Apex Textile Printing Mills Ltd

Chandora, Kaliakoir, Gazipur, Dhaka
(+24.043819N, 90.260622E)

14 December 2013

Building Observations

Floor Storage loads

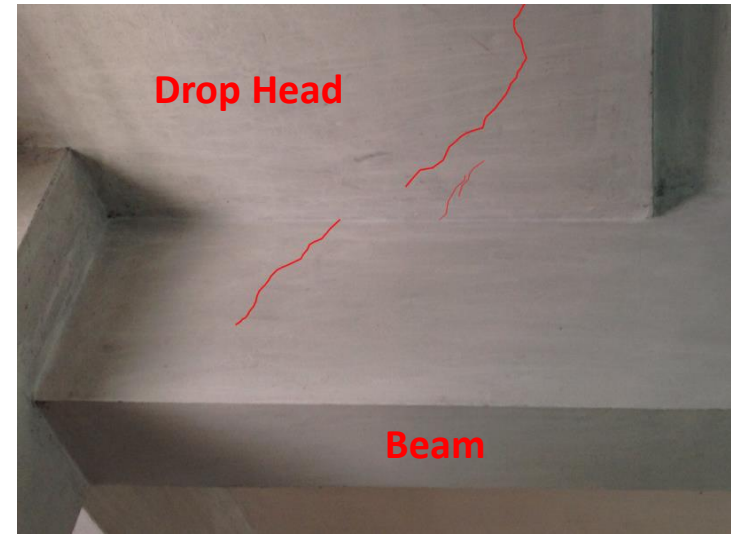
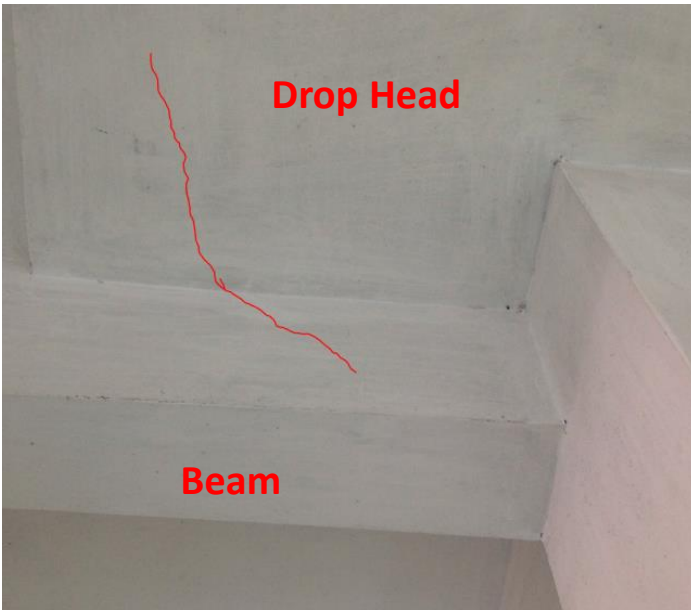
Load management of storage loads

Plan and height restrictions to be introduced to prevent future overloading.

Plan and height restrictions to be introduced to prevent future overloading.

Item No.	Observation	Recommended Action Plan	Recommended Timeline
5	Load management of storage loads	Produce and actively manage a loading plan for all floor plates within the factory giving consideration to floor capacity, (including punching shear), and column capacity.	6-weeks
6	Cracking to underside of concrete beams, slabs, drop heads and partitions.	Sections of plaster finish to beams/slab to be removed to investigate if cracks penetrate the building structure.	6-weeks
7	Cracking to underside of concrete beams, slabs, drop heads and partitions.	Cracks in brick wall to be reviewed to identify the cause and confirm that it is non structural	6-weeks
8	Cracking to underside of concrete beams, slabs, drop heads and partitions.	Building Engineer to carry out design check on beams/slab to confirm that these cracks are non-structural.	6-months
9	Cracking to underside of concrete beams, slabs, drop heads and partitions.	Building Engineer to issue details of repair works to be completed	6-months

**Crack in beam and drop head –
u/side 6th floor**

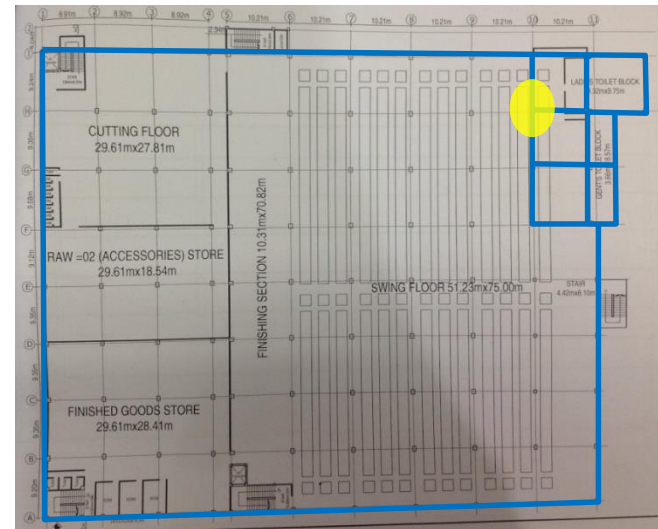
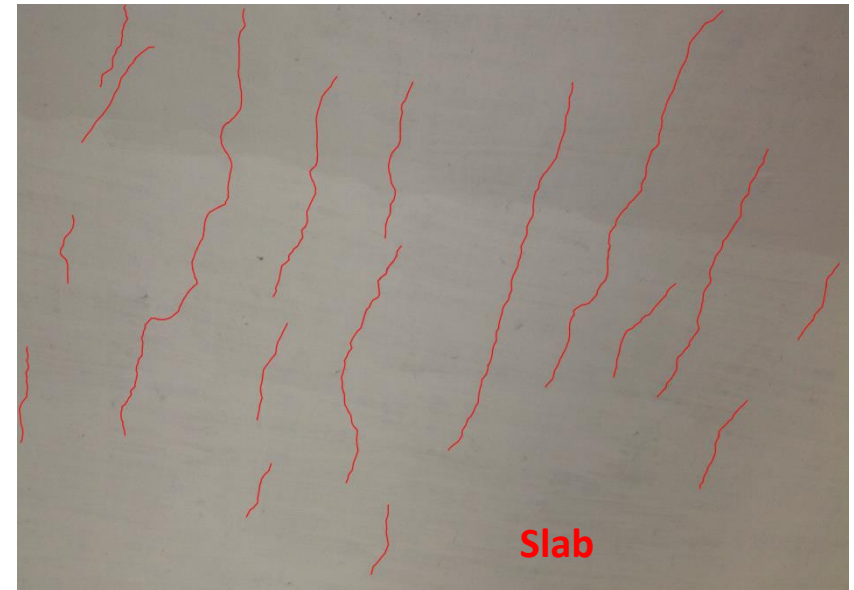
**Cracking pattern to concrete
beams and drop heads on the
underside of 6th floor slab**

Crack in beams, slabs and drop heads at area highlighted in yellow – u/side 6th floor

**Building
Movement
Joint**

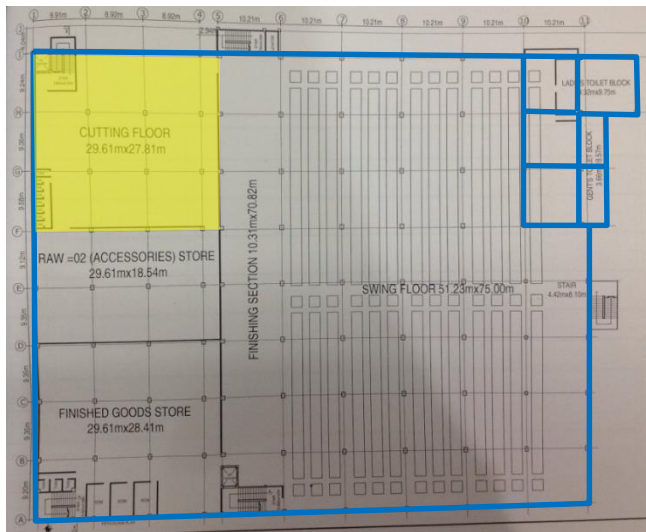
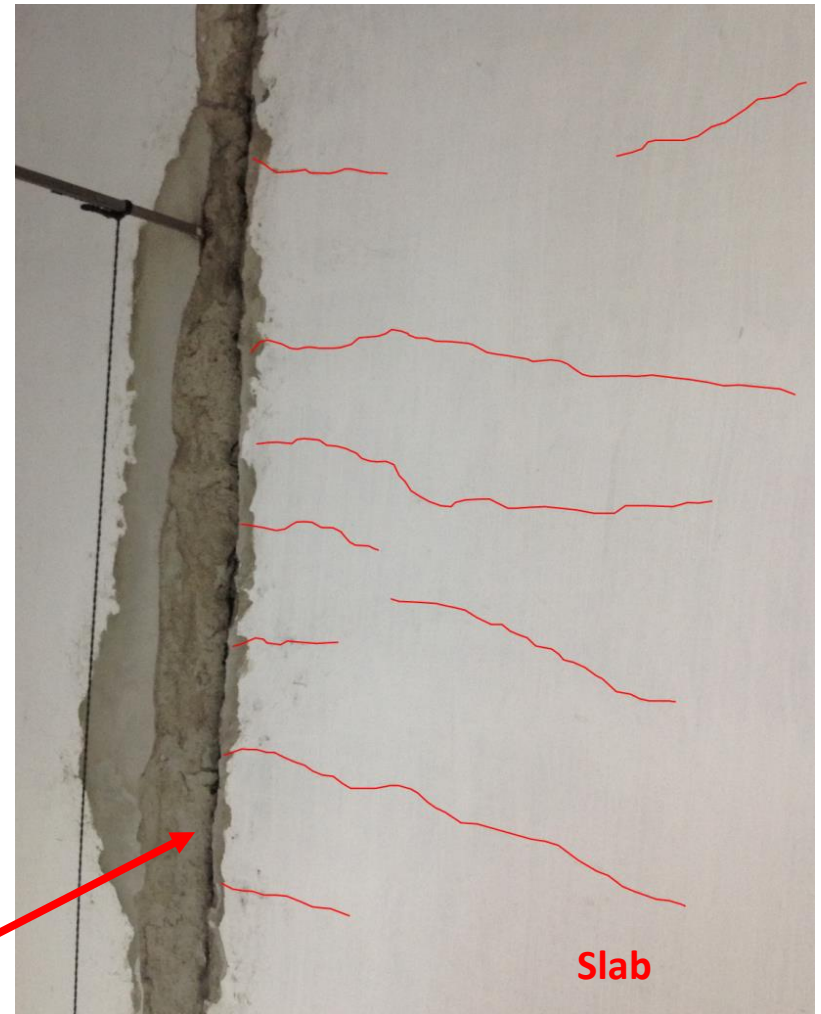
Crack in slab at the movement joint at area highlighted in yellow – u/side 6th floor

**Horizontal crack in column –
Ground Floor Mezzanine**

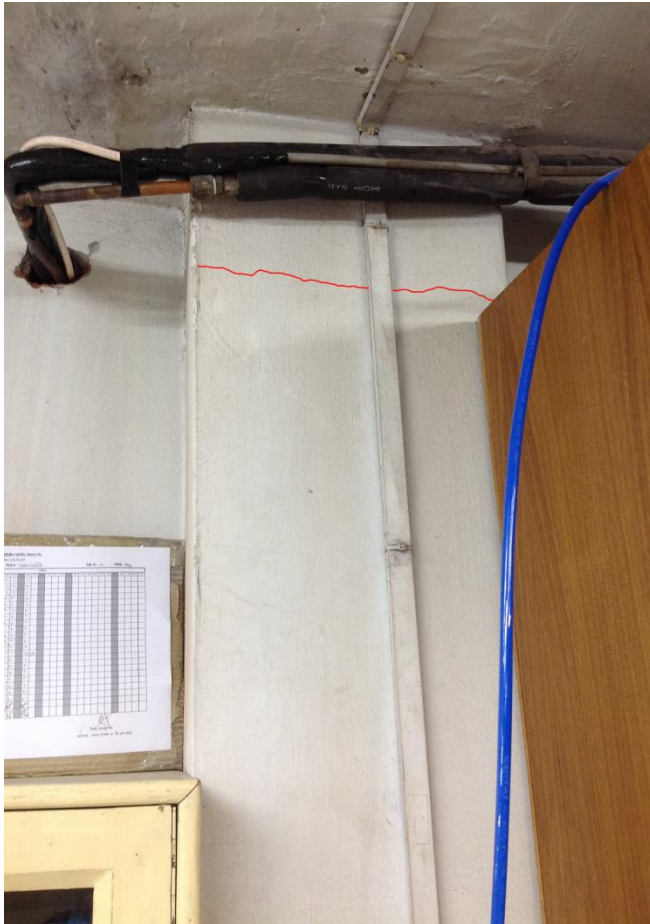
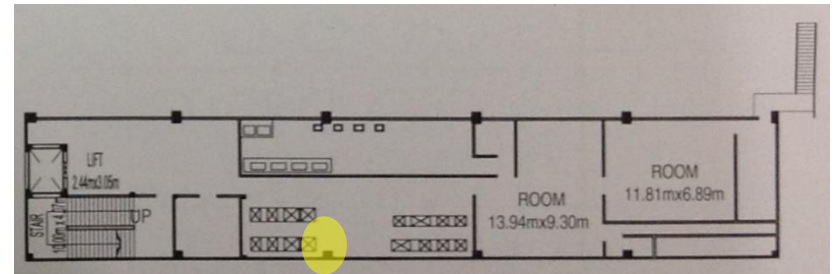
Crack in column

Cantilever at Movement Joint

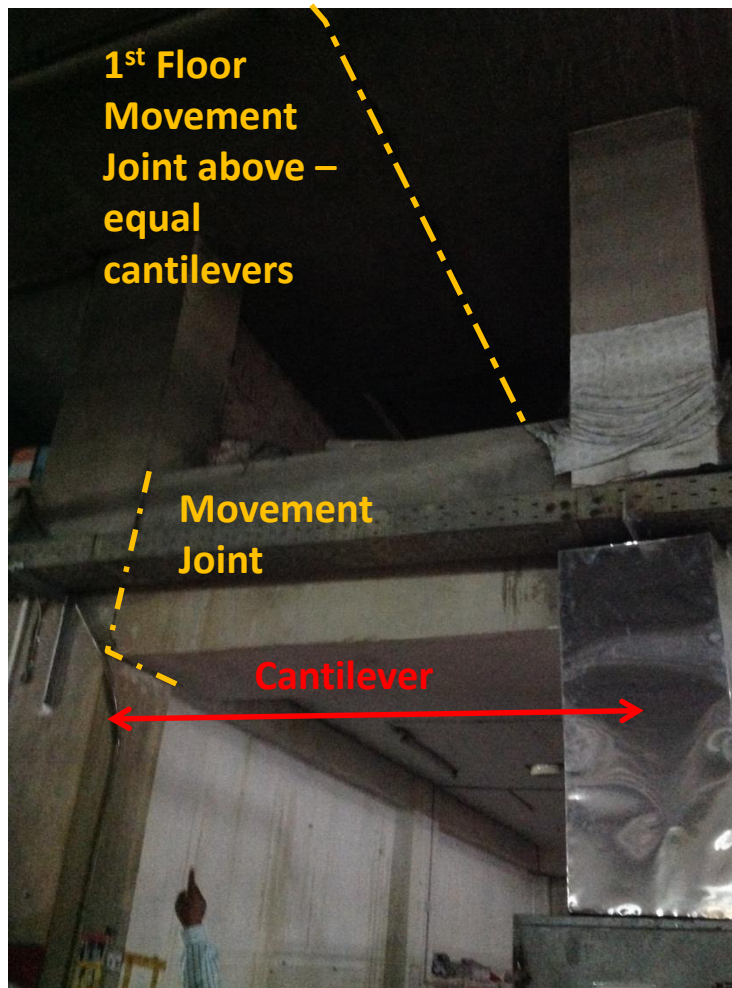
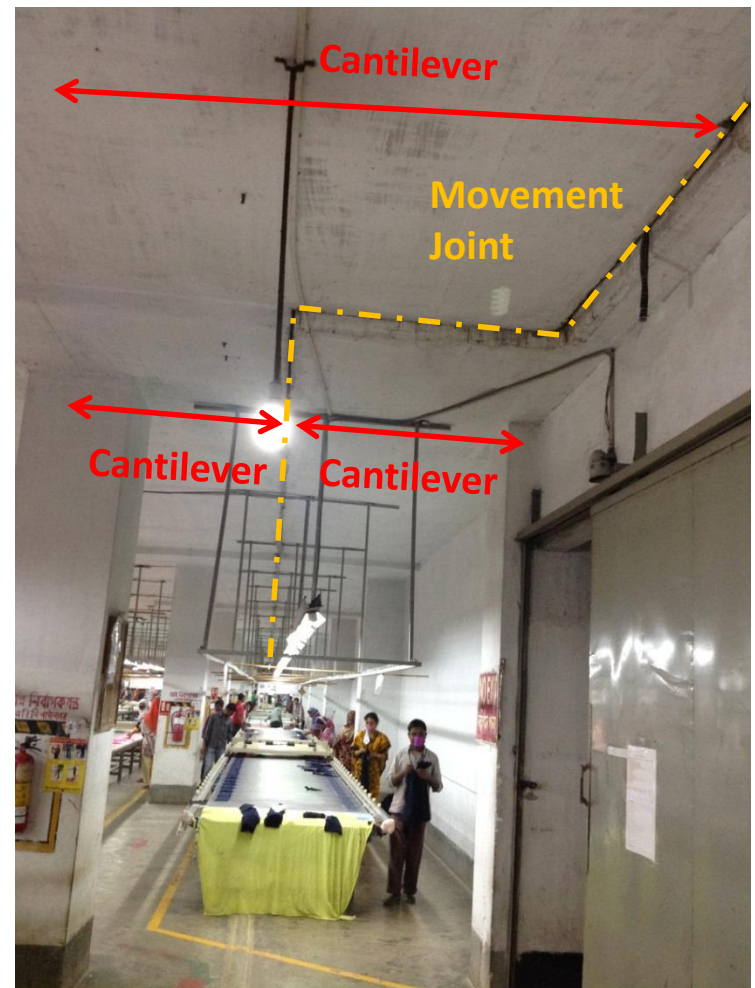
Stepped floor slab alignment at movement joint – capacity of cantilever floor slab to be checked

Item No.	Observation	Recommended Action Plan	Recommended Timeline
10	Stepped floor slab alignment at movement joint – capacity of cantilever floor slab and mezzanine beam to be checked.	Building Engineer to review typical floor plate design at the south east side of the movement joint and carry out design check calculations to confirm that slab is adequately designed for the increase cantilever span.	6-weeks
11	Stepped floor slab alignment at movement joint – capacity of cantilever floor slab and mezzanine beam to be checked.	If required the load capacity of the floor plate may be reduced locally - Refer to Item 1; requirement for Allowable Floor Loading Plans	6-weeks
12	Stepped floor slab alignment at movement joint – capacity of cantilever floor slab and mezzanine beam to be checked.	Design check required to confirm that north/south ground floor mezzanine beam is structurally adequate adjacent to movement joint.	6-weeks
